Re: Koss Construction LLC (“**the Developer**”) (Tax Map Lots 140-16 & 170-12) Bean Road (“**the Project**”)
CWS Moultonborough: Harbor Landing: PWS ID: New System
Proposed BRW1 and BRW2; NHEDS#DR006013

**SUBJECT: Letter Report and Opinion on Well Impacts
Bean Road Development Site Review
Center Harbor, New Hampshire**

At your request, we have reviewed the report prepared by Edgewater Strategies (Edgewater) dated July 8, 2023, and titled *Small Community Preliminary Well Siting Application Form, Supplemental Information Submittal for Harbor Landing, Moultonborough, NH for Proposed BRW1 and BRW2* including its associated attachments concerning per-and polyfluoroalkyl substances (PFAS) contamination in bedrock wells located to the west of the proposed development. We also reviewed the document described as 2021 Koss Well Docs which contains the initial pumping test data and report for the preliminary pumping test of bedrock wells BR1 and BR2 conducted on January 24, 2021. You requested our opinion on the potential impacts, if any, of the proposed use of BR1 and BR2 considering the contaminants on nearby properties. We have considered those impacts, especially at the applicant's pro

Figure 1
Estimated Pumping Cone of Depression BR1 and BR2

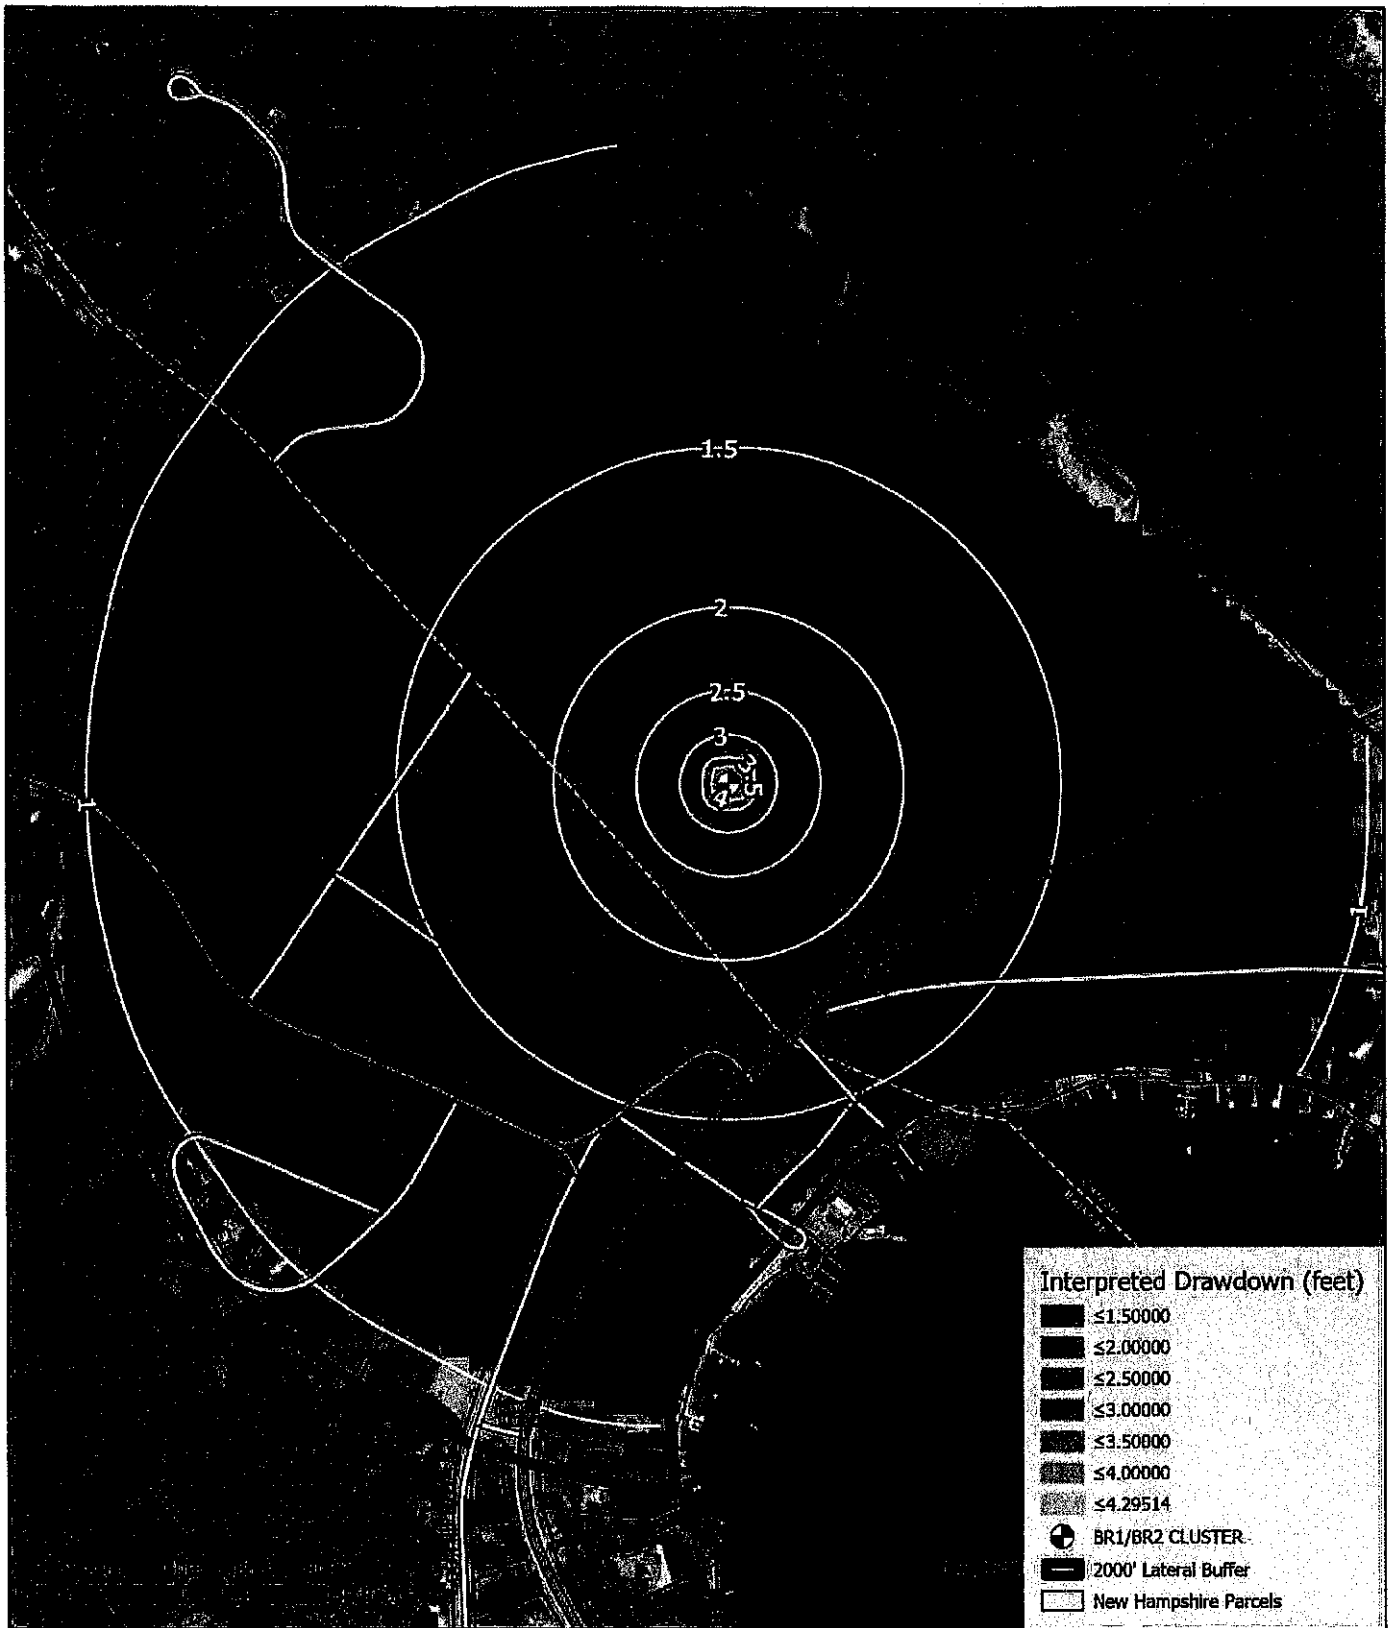
Figure 1 and Exhibit 1-D indicate that hydrologically significant drawdown (>1 foot) can be expected at least 1,600 feet from the proposed pumping wells after several (4) days of pumping. This will result in a high probability of capture and eventual transport of PFAS impacted bedrock groundwater, and other contaminants, by the proposed pumping wells. The time frame for detecting changes in solute concentrations is likely to be on the order of months to years due to other transport considerations that retard transport rates such as advection, dispersion, diffusion in microfractures, and solute sorption to iron oxide mineral surfaces on fractures. Chemical changes are not expected to occur within the limited timeframe of the proposed pumping test (several days) as suggested by Edgewater. That expectation does not appear to be well informed considering the time it takes for transport of a groundwater plume in a bedrock regime.

Based on these considerations we do not concur with Edgewater that operation of these wells can occur without high probability of long-term adverse effects. As such, it is our opinion that pumping the proposed bedrock wells poses an unreasonable risk of impacting the current distribution of PFAS and causing eventual migration of PFAS impacted groundwater toward the proposed wells BR1 and BR2. Accordingly, the requested waivers are inappropriate under these circumstances.

EXHIBIT 1-A Pumping Test Drawdown Summary

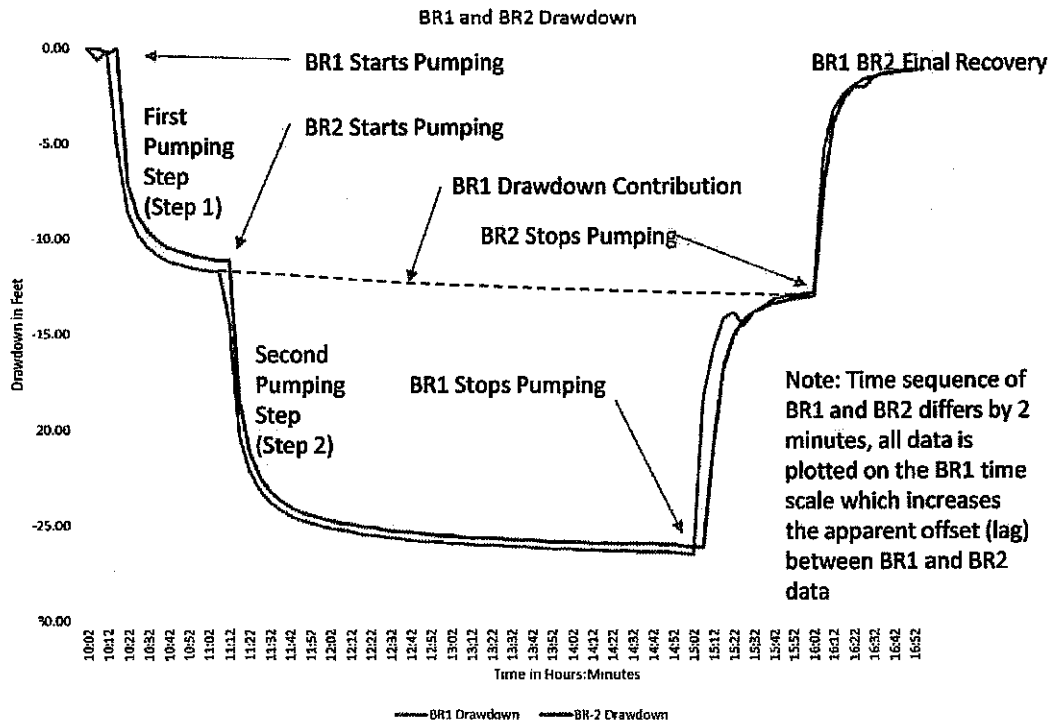
Exhibit 1-A presents a plot of the combined drawdown of BR1 and BR2 during the Edgewater pumping test as developed by Credere. BR1 was pumped at an average rate of 34.60 gpm and one hour later BR2 was turned on and pumped at an average rate of 33.65 gpm. The combined average was 68.26 gpm. Each well was pumped for 5 hours. Please note that the groundwater drawdowns in BR2 and BR1 are nearly identical when only BR1 was pumping (Pumping Step 1). When both wells were pumped (Pumping Step 2), water levels in both wells were also nearly identical. This illustrates that the wells and aquifer are well connected and can be treated mathematically as one well. The combined average maximum drawdown was 26.29 feet. When BR1 was turned off, both wells recovered approximately halfway. When BR2 was turned off both wells recovered to within 98 percent of static. Edgewater reported specific capacities of each well at approximately 1.3 gpm/foot of drawdown (gpm/ft). This is incorrect. This was computed as the pumping rate at each well divided by the total drawdown. The drawdown was the result of the combined pumping because the wells were pumped together so the individual pumping rates should not have been used. The corrected specific capacity is the total pumping rate divided by the total drawdown or 2.6 gpm/ft. Because the pumping test combined two wells rather than pumping BR1 for 5 hours, shutting it down, and after reaching static pumping BR2 for 5 hours, analysis of the pumping test results can be treated as a step test for "one combined" well where BR1 is the first step and the combined BR1 and BR2 rate is the second step. It is possible to estimate the drawdown of BR-1 based on the graph (see dashed line).

EXHIBIT 1-B Shallow Bedrock Step 1 Test Curve Match BR1 Pumping

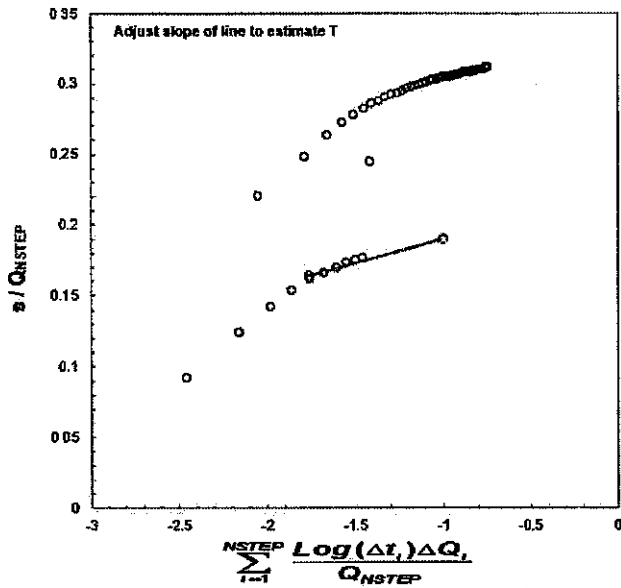
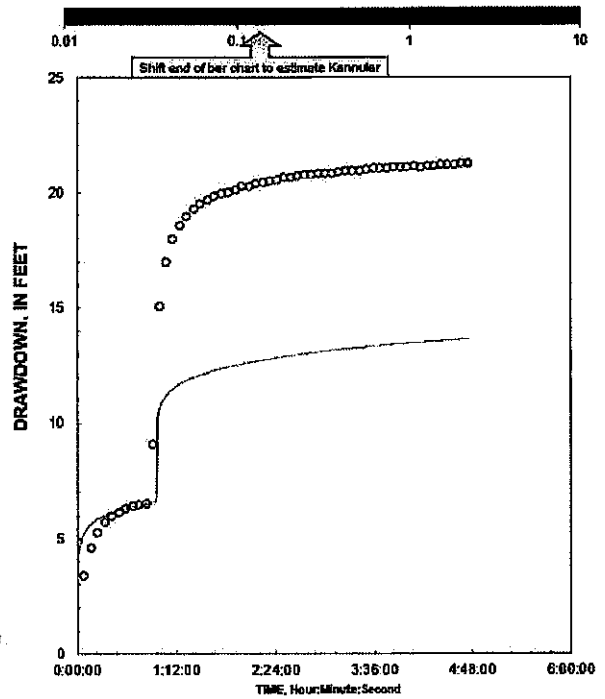
Exhibit 1-B shows the results of an analysis of the pumping test results which was conducted using publicly available pumping test analysis tools presented in the US Geological Survey Open File Report 02-197. In this manner our assumptions and conclusions can be independently validated or refuted. Specifically, this included the step drawdown method which is analogous to the Cooper-Jacob method at higher pumping rates. **Exhibit 1-B** presents the curve match for the shallow bedrock or Step Test 1 (hours 0-1) for BR1. Although the

analysis required extrapolation of the drawdown slope due to the early nature of the data, the results of the curve matching are acceptable and indicate a transmissivity (T) of 1,030 ft²/day and a hydraulic conductivity (K) of 4.29 ft/s and with a storativity (S) of 0.0095. These values are slightly higher than the later data which affected deeper bedrock at a higher pumping rate (Step 2) which is consistent with a conceptual model that the shallow bedrock is more weathered, has more and larger fracture apertures, and therefore has slightly higher T and S values.

REMARKS: Step-drawdown analysis of single-well aquifer test. Test Data match is early data from BR1 and may represent response with higher K in shallower weathered bedrock. K=4.29 ft/day S=0.0095 which is borderline for confined conditions

EXHIBIT 1-C Deeper Bedrock Step 2 Test Curve Match BR1 and BR2 Pumping

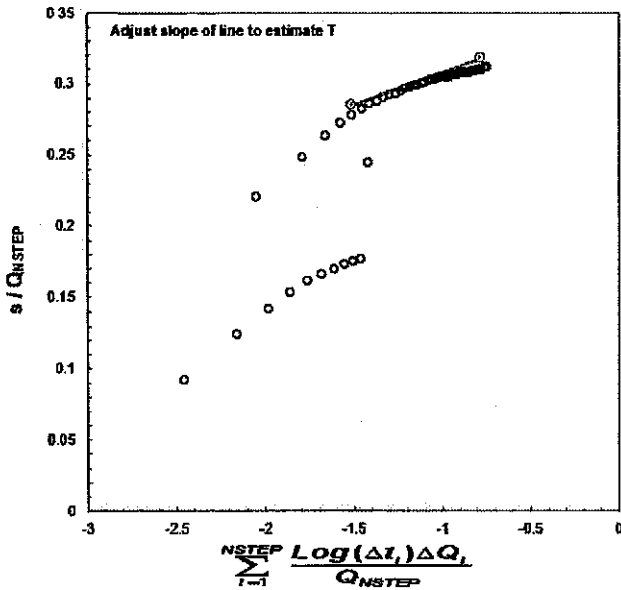
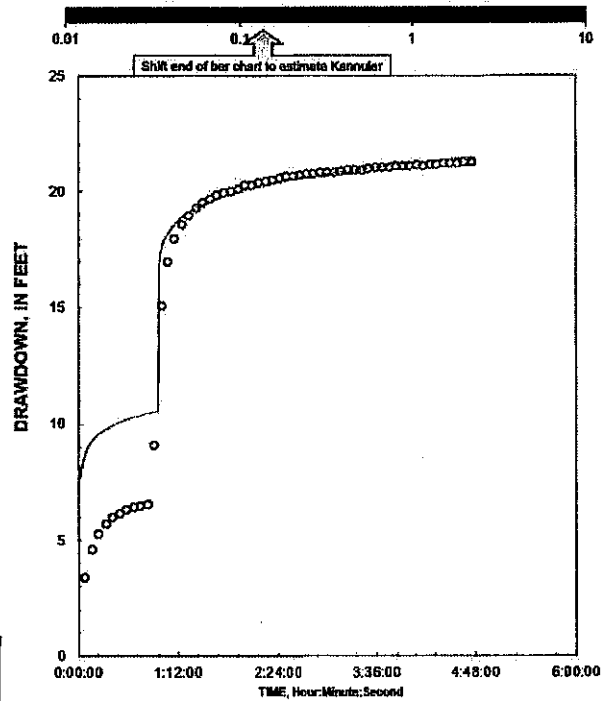
Exhibit 1-C shows the analysis of the later (1-5 hours) data based on the second step with the combined pumping rate of BR1 and BR2 which averaged 68.26 gpm with a maximum drawdown of 26.29 feet averaged between the wells. The best curve match for this bedrock with deeper drawdown indicates a lower transmissivity of 775 ft²/day with a K of 3.22 ft/d and a storativity of 0.00015. This suggests the deeper bedrock has lower transmissivity and storativity than the shallow bedrock which is consistent with accepted bedrock conceptual models in New England, where weathering and glacial stresses resulted in more transmissive shallow bedrock.

REMARKS: Step-drawdown analysis of angle-well aquifer test
 Test Data Step 2 with Wells BR1 and BR2 Pumping Curve Match at K=3.22 ft/day, S=0.00015

EXHIBIT 1-D This Distance Drawdown Calculation for Confined Aquifers Input Screen

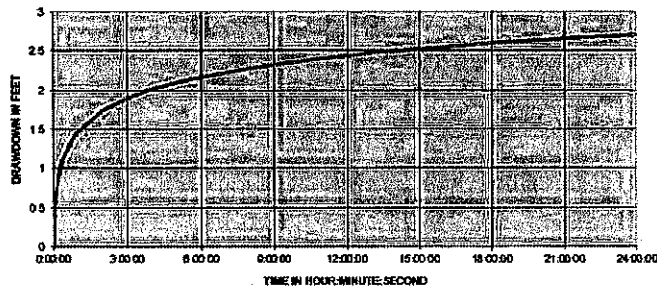
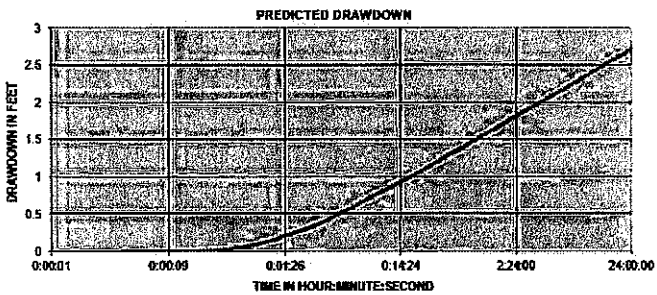
Exhibit 1-D presents the results of calculations of the distance drawdown for pumping the combined BR1 and BR2 at the design discharge rate of 17.5 gpm (8.75 gpm per well). The method used is the Theis solution for confined aquifers. This analysis uses the more fully developed aquifer parameters from Exhibit 1-C and is simplified by the assumption that pumping of the two closely spaced wells is approximated by pumping one well at the combined rate of 17.5 gpm. This assumption is justified by the data presented in Exhibit 1-A. The exhibit presents a screen shot of the calculation input sheet and results followed by a compilation of the calculated distance drawdown data for time frames of 24, 48 and 96 hours of pumping. The 96-hour values are used in the interpretation in **Figure 1**. The aquifer parameters used for these calculations include a K of 3.22 ft/d and S of 0.00015. The effective aquifer thickness (b) was adjusted to 213 feet (versus 240 feet) so that the calculated drawdown (at five hours) adjacent to the pumping well (R=0.25 feet) matched the drawdown in the pump test at five hours when BR1 and BR2 were pumped at a combined rate of 68 gpm.

- 1 Step Test Averaged 68 gpm for BR1 and BR2 Combined Pumping
 Aquifer depth 380 feet, Cased to 60 feet. Available Aquifer 240 feet for computation of T&S
 S=0.00015 best fit
 K = 3.22 ft/d
- 2 Pumping Test Drawdown was 26.29 at 5 hours
 At 68 GPM at 5 hours this solution 26.35
- 3 Calculation is reasonable for Estimates of Time & Distance Drawdown
- 4 Computation sheet has been expanded to 48 and 96 hours
- 5 Specific capacity 2.5864 gpm/ft
